<b>Docket Number:</b>	11-AFC-04
<b>Project Title:</b>	Rio Mesa Solar Electric
<b>TN #:</b>	233548
<b>Document Title:</b>	Applicant's Supplemental Response to Data Requests 8 and 16 Additional Information Regarding Air Quality
<b>Description:</b>	N/A
<b>Filer:</b>	Marichka Haws
<b>Organization:</b>	California Energy Commission
<b>Submitter Role:</b>	Commission Staff
<b>Submission Date:</b>	6/19/2020 2:55:07 PM
<b>Docketed Date:</b>	6/19/2020

## **APPLICANT’S SUPPLEMENTAL RESPONSE TO DATA REQUESTS 8 AND 16: ADDITIONAL INFORMATION REGARDING AIR QUALITY**

# **Air Quality/Public Health Analysis for Two-Plant Design Rio Mesa Solar Electric Generating Facility**

<b>AIR DISPERSION PLOT PLAN COMMON AREA</b>																				
PE STAMP		JOB NO.	DRAWING NO.	REV.																
		25755	009-H1-0010-00001	B

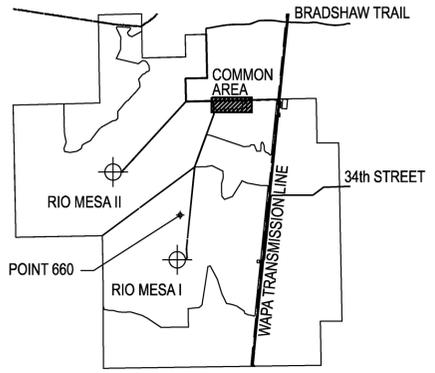
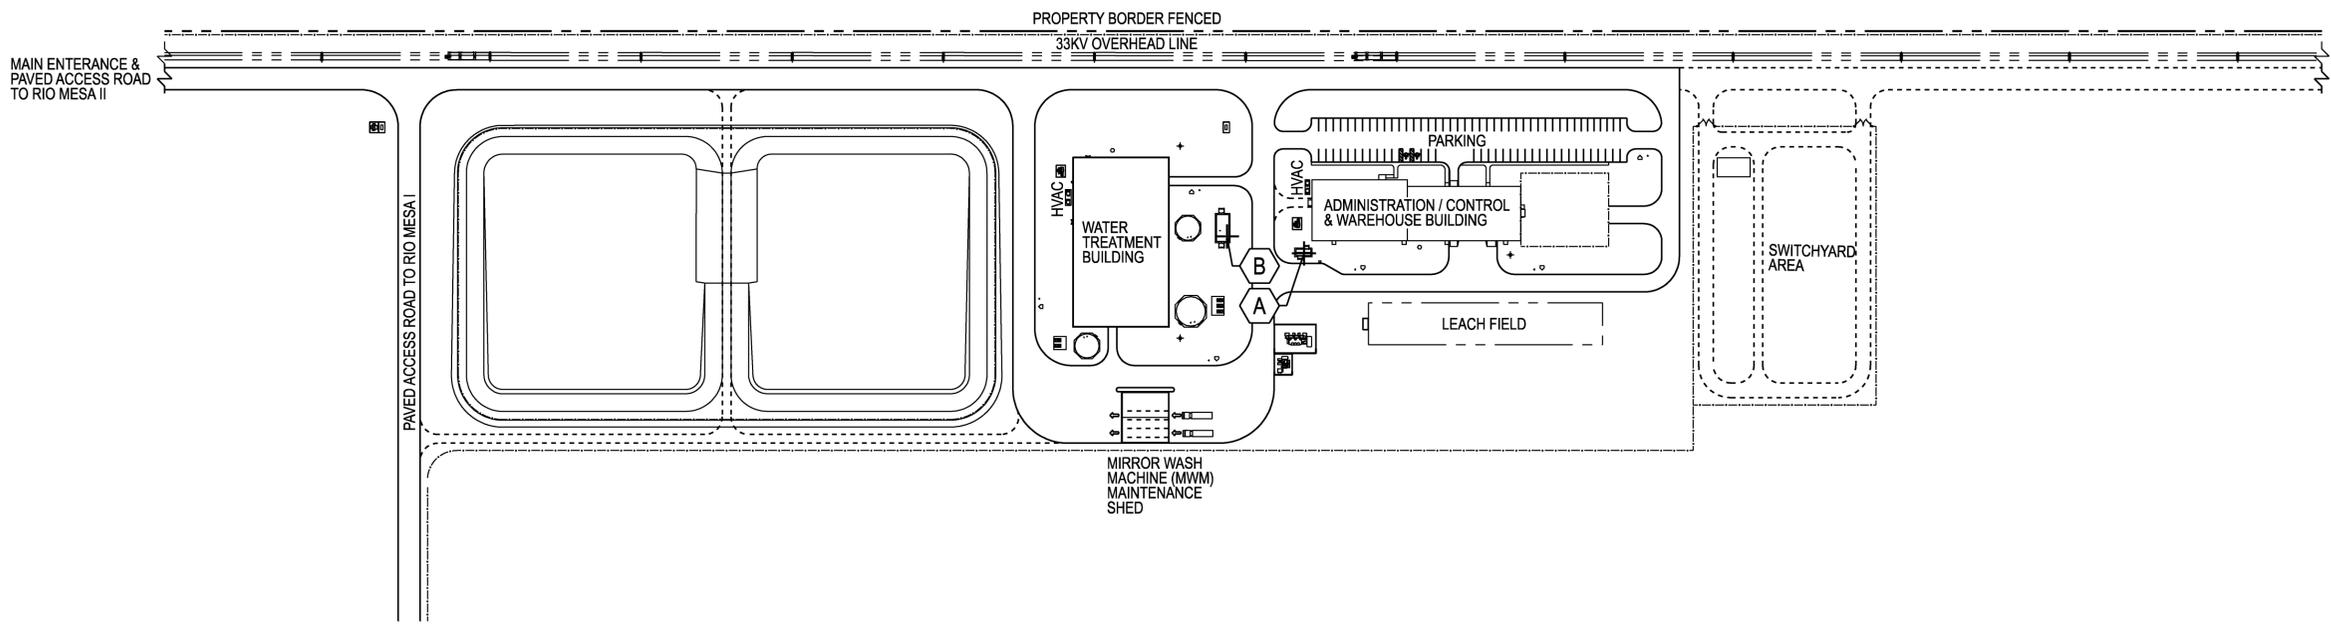
The enclosed analysis summarizes the changes to emissions, ambient air quality modeling impacts, and public health impacts associated with the two-plant design. The revised solar field layout and common area plot plan are included as Attachment 1, and detailed emission calculation summary tables for the two-plant design are included as Attachment 2 in the enclosed document. In addition, the detailed air quality modeling input/output files are included on the enclosed compact disc. We will send a separate confidential submittal to the District containing the spreadsheet with the detailed emission calculations for the two-plant design.
